Access Compliance Report

Public Rights-of-Way

(Curb Ramps)

Intersection ID: 2743	Main Street: BELL'S_MILL_DR	Cross Street: HIGHLAND_CREEK_PY	Location: NE
ADA ID: C1255B549EE1	Ramp Type: Perp	Initial Pass/Fail: Fail	Overall Compliance: No
Severity Score: 22.5			
Codes/Mitigation Info/Possible Solution		Field Measurements/Component Compliance

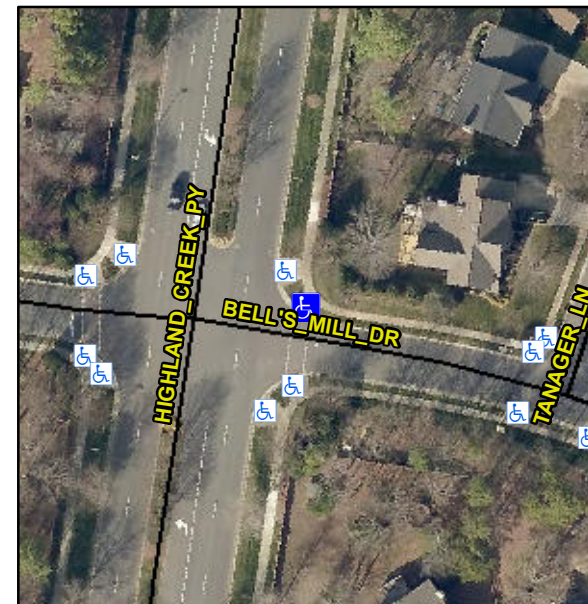
R304.5.1, R304.2.2, R304.5.3

Compliance	Description	Data	Compliance	Description	Data
N/A	Ramp Length (in)	90.0	No	Ramp Slope (%)	9.0
No	Ramp Width (in)	42.0	No	Ramp XSlope (%)	2.1
N/A	Flare Type LT	N/A	N/A	Flare Type RT	N/A
N/A	Flare Slope LT (%)	N/A	N/A	Flare Slope RT (%)	N/A
N/A	Flare Traversable LT?	N/A	N/A	Flare Traversable RT?	N/A
N/A	Landing Length (in)	N/A	N/A	DWS Provided?	N/A
N/A	Landing Width (in)	N/A	N/A	DWS Contrast?	N/A
N/A	Landing Slope (%)	N/A	N/A	DWS Length (in)	N/A
N/A	Landing X Slope (%)	N/A	N/A	DWS Full Width?	N/A
N/A	Landing Curb? (Y/N)	N/A	N/A	DWS Offset (in)	N/A
N/A	Shared Landing?	N/A			
N/A	Gutter Ponding?	N/A	N/A	Gutter Slope (%)	N/A
N/A	Gutter Lip Ht (in)	N/A	N/A	Gutter X Slope (%)	N/A
N/A	Painted X Walk1?	Yes	N/A	Painted X Walk2?	N/A
	X Walk 1 Direction	To SW		X Walk 2 Direction	N/A
N/A	X Walk 1 Width (in)	96.0	N/A	X Walk 2 Width (in)	N/A
	X Walk 1 Slope (%)	2.5		X Walk 2 Slope (%)	N/A
	X Walk 1 X Slope (%)	2.5		X Walk 2 X Slope (%)	N/A

Remove & Replace Entire Ramp.
